TECHNICAL EVALUATION REPORT
SAN ONOFRE NUCLEAR GENERATING STATION UNIT 1
STATION BLACKOUT EVALUATION

TECHNICAL EVALUATION REPORT

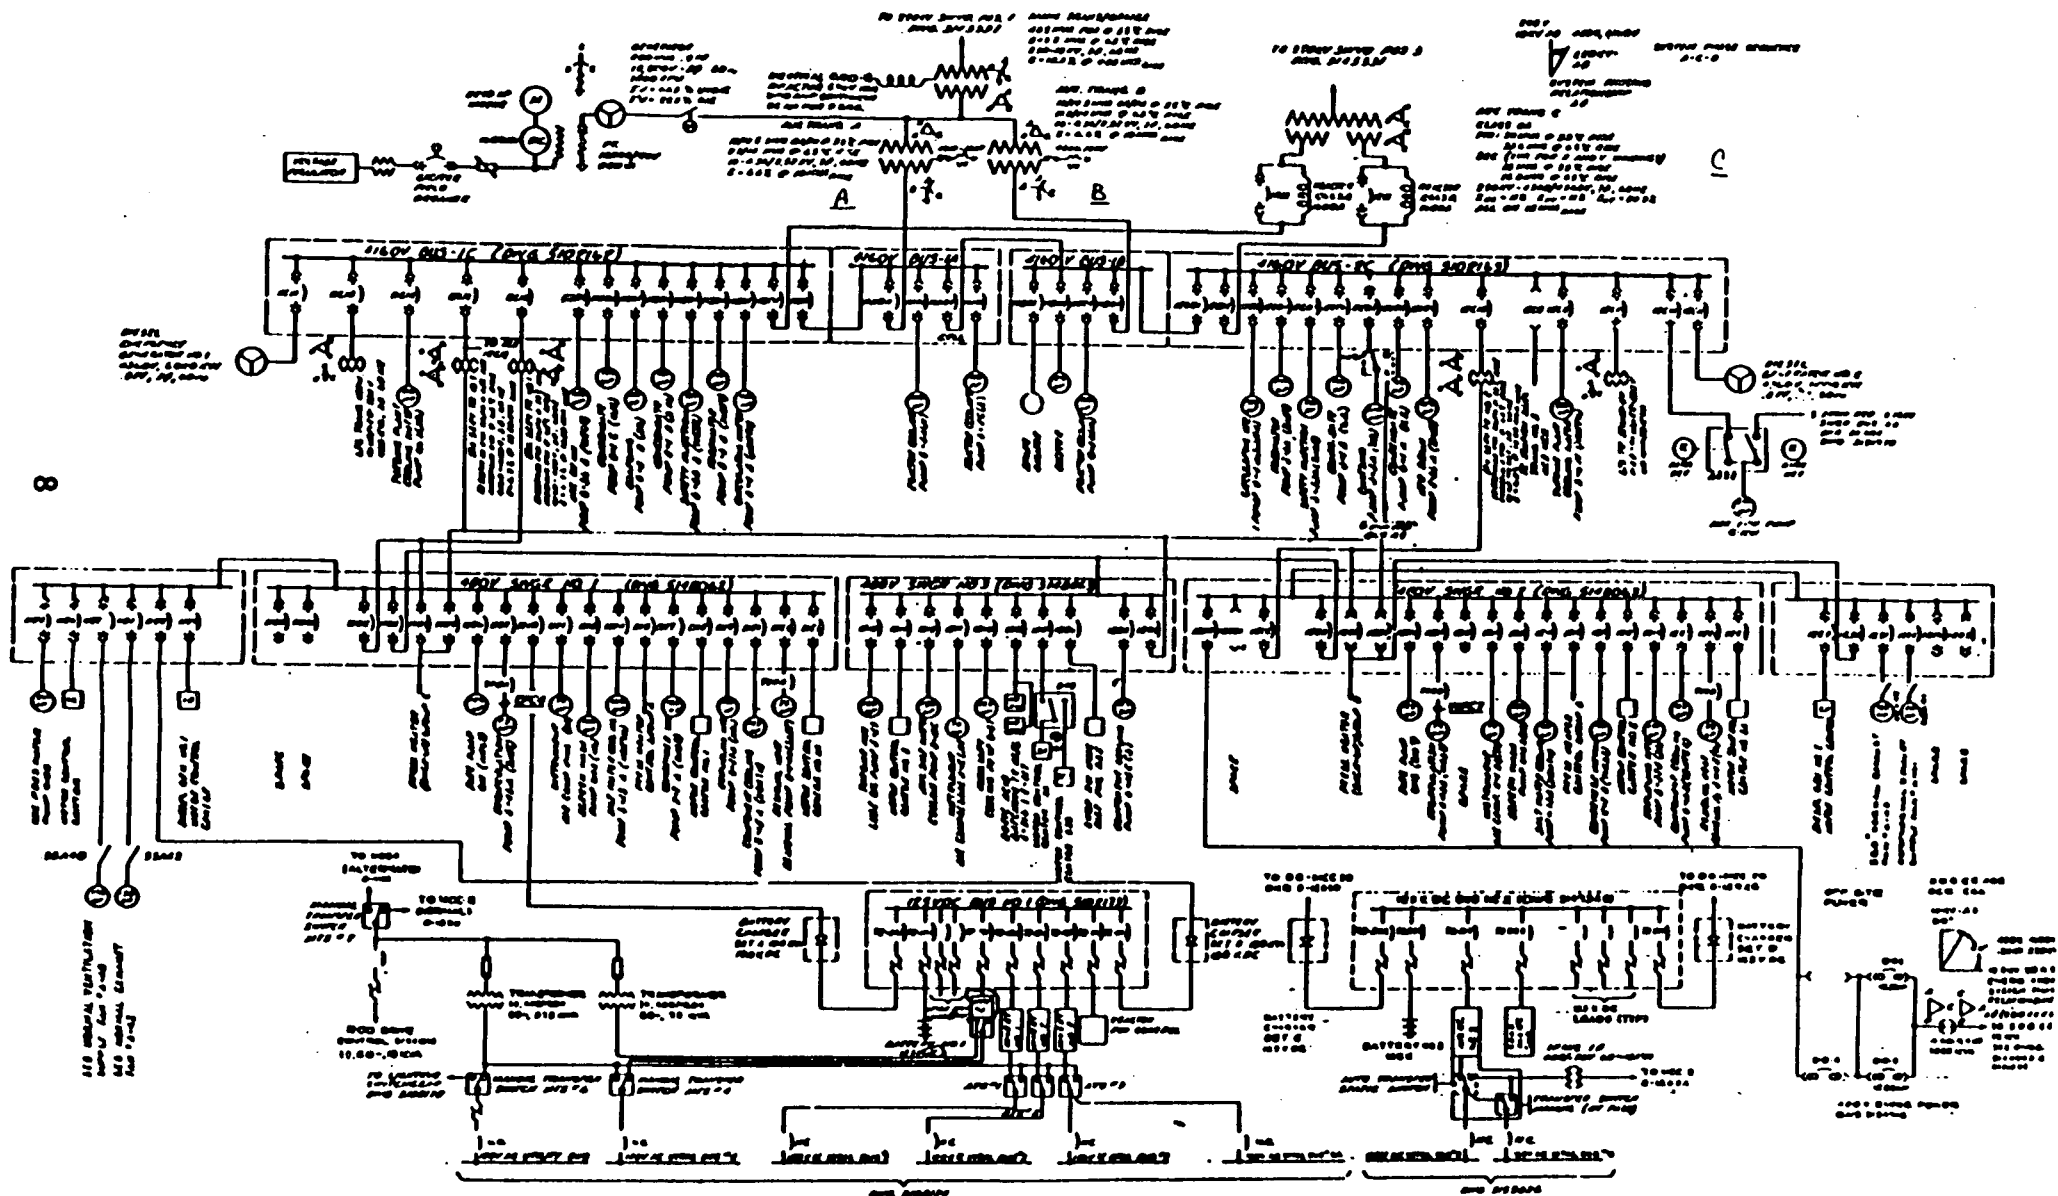
San Onofre site has two electrically connected switchyards, one owned by Southern California Edison (SCE) and one owned by San Diego Gas and Electric. The SCE switchyard is used for SONGS 1 outgoing (generated) power and incoming power. As shown in Figure 1 (15), the unit's auxiliary transformers A and B take power directly from the main generator's output and supply 4160 V buses 1A and 1B. Safety buses 1C and 2C are normally powered from the buses 1A and 1B. Upon failure of the main generator, the 4160 V buses (1A, 1B, 1C and 2C) are isolated from their respective auxiliary transformers and the generator is isolated from the grid. When the generator's voltage drops to 40% of nominal, a 30-second delay period is initiated. After the delay period, the main generator motor-operated disconnect starts to open. When the disconnect is fully open, 4160 V buses are re-energized from auxiliary

transformers A and B, which are the preferred source of back-up offsite power. According to the unit UFSAR, this cycle takes approximately two minutes. If the preferred source of power is not available, the safety buses 1C and 2C can be manually energized from auxiliary transformer C. Therefore, we agree with the licensee's conclusion that SONGS 1 is in offsite power group "I2."

FIGURE 2. SONGS 1 ALTERNATE AC POWER SYSTEM

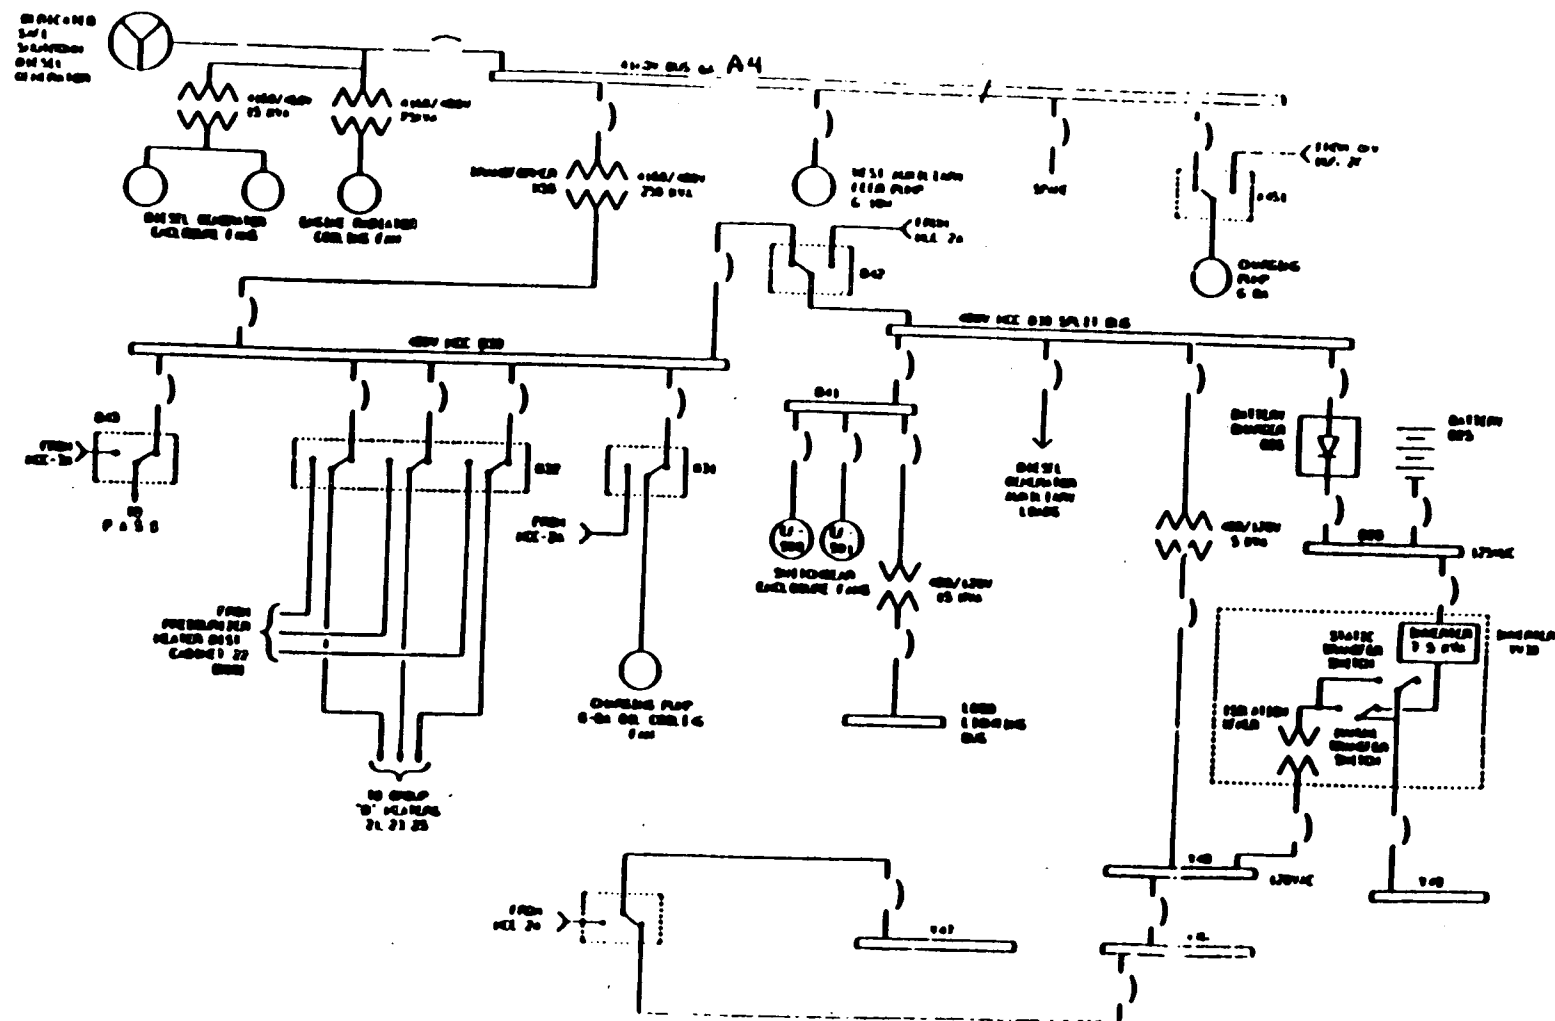
The AAC source is the non-class 1E DSD diesel located in a dedicated room to the west of the turbine building. The DSD system is not connected to the plant's safe shutdown buses; it supplies alternate power to selected equipment necessary to safely maintain the plant in hot standby. Since it is both electrically and physically separate from the class 1E electrical systems, and installed to meet the 10 CFR 50 Appendix R criteria, it meets criteria B.1 through B.7 of NUMARC 87-00, Appendix B.

During the telephone conversation on June 22, 1990, the licensee stated that the DSD diesel has a dedicated air-start system, fuel supply and storage system, and an eight hour battery. The engine is cooled by a radiator which needs no support from any plant systems. Based on this information, the DSD diesel should meet criteria B.8 of NUMARC 87-00, Appendix B.

In response to questions asked during the telephone conversation of June 22, 1990, the licensee submitted a list of loads connected to the DSD diesel (14). The loads, including a charging pump, an auxiliary feedwater pump, pressurizer heaters, lighting, diesel battery charger and assorted auxiliary loads, require a total of 1,057 kW, which is considerably less than the DSD capacity of 2,000 kW. Therefore, we agree that the DSD has adequate capacity to power all connected loads and meets criteria B.9 of NUMARC 87-00.

The licensee stated that the DSD diesel surveillance requirement is controlled by Technical Specification 4.15.8, which includes a requirement for quarterly demand testing. The licensee has committed to develop a reliability program for the DSD diesel (13). Although this surveillance would enhance the reliability of the DSD diesel, the

licensee needs to demonstrate and maintain a 0.95 reliability for the AAC power source. The licensee stated (13) that a time and man power study of implementing the Appendix R procedures showed that the DSD diesel can be brought on line within 20 minutes of the onset of an SBO, and that a new timed test will be performed during the next refueling outage. The licensee needs to perform and document the above test to demonstrate that the safe shutdown equipment can be powered within one hour of an SBO event.
